**NUCLEAR MANAGEMENT COMPANY, LLC
PALISADES NUCLEAR PLANT, DOCKET 50-255, LICENSE DPR-20
CORRECTION TO FIRE PROTECTION EXEMPTION REQUEST**

**NUCLEAR MANAGEMENT COMPANY, LLC
PALISADES PLANT
DOCKET 50-255**

**Corrected Figure 3B of Attachment 15
To Exemption Requests Dated July 20, 1984 and June 19, 1985**

PALISADES PLANT
FIGURE 3B
ATTACHMENT 15

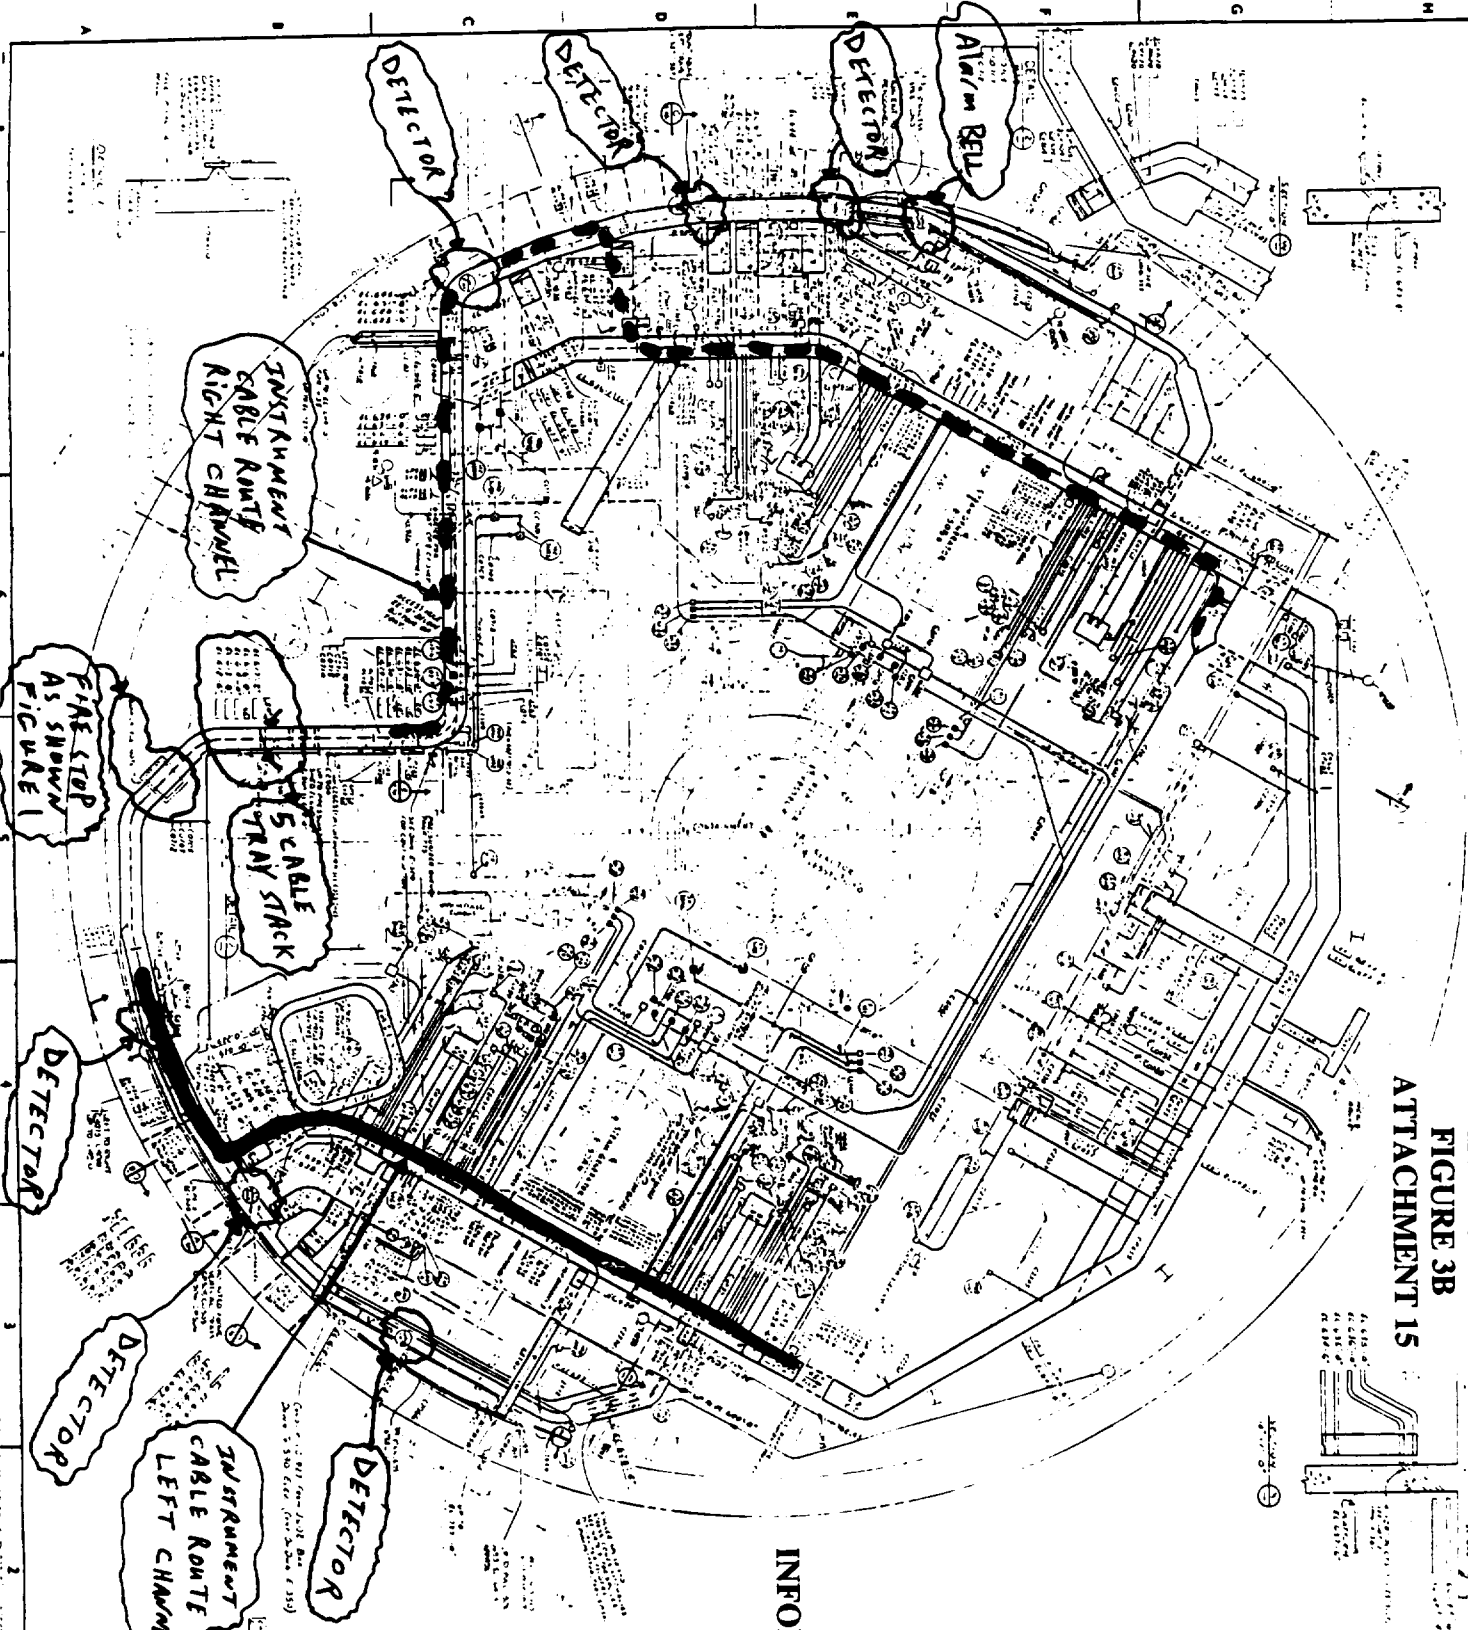
Figure 3B to Attachment 15 of the July 20, 1984 and June 19, 1985 submittals provided information that included identification of the location of fire detectors in the containment 607' elevation area. Four fire detectors were originally, and incorrectly, denoted in the area for the right channel instrument cable route. NMC is enclosing a corrected Figure 3B which denotes three fire detectors. These fire detectors are installed in areas of cable concentration. The previously identified fourth detector, labeled "alarm bell," is a local alarm that is energized upon smoke detector actuation in the containment. There are no cable concentrations between the alarm bell and the adjacent fire detector. NMC has determined that the remaining three smoke detectors are adequate to provide fire detection in the areas of cable concentration as stated in the NRC exemption dated July 23, 1985.

Enclosure 1 provides the revised Figure 3B of Attachment 15 to the exemption requests dated July 20, 1984 and June 19, 1985.
